# Maule Aircraft Corporation

## SERVICE LETTER #30

**Subject:** Right Side Exhaust System Hanger Brace

**Models Affected:** M-4-220 Aircraft, All Serial Numbers  
M-5-220 Aircraft Serial Numbers 5001C through 5024C.

Figure A

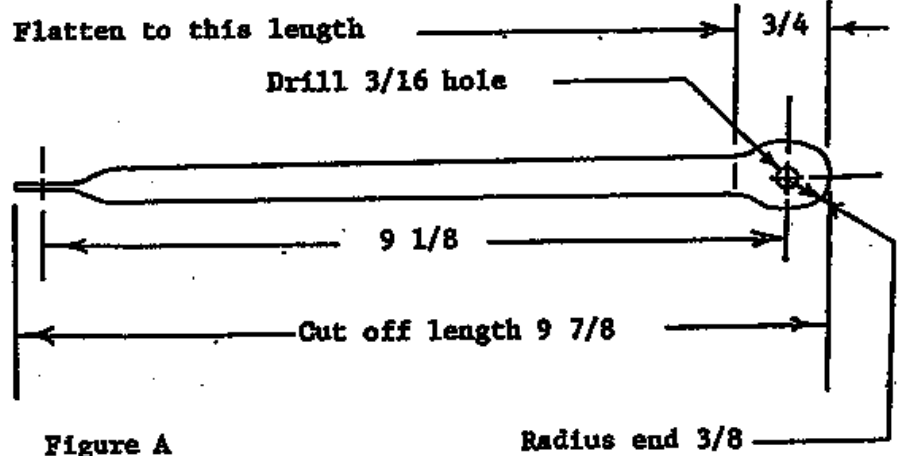
**Background:** Exhausts braced to the tab on the engine header stack put too much strain on the stack.

**Description:** If the Right Side Exhaust System is braced to the engine stack, remove the brace and rework it to the configuration shown in Figure A below. Attach it to the alternator mount by Bracket 5192 B-2 as shown in Figure B below.

Radius end 3/8
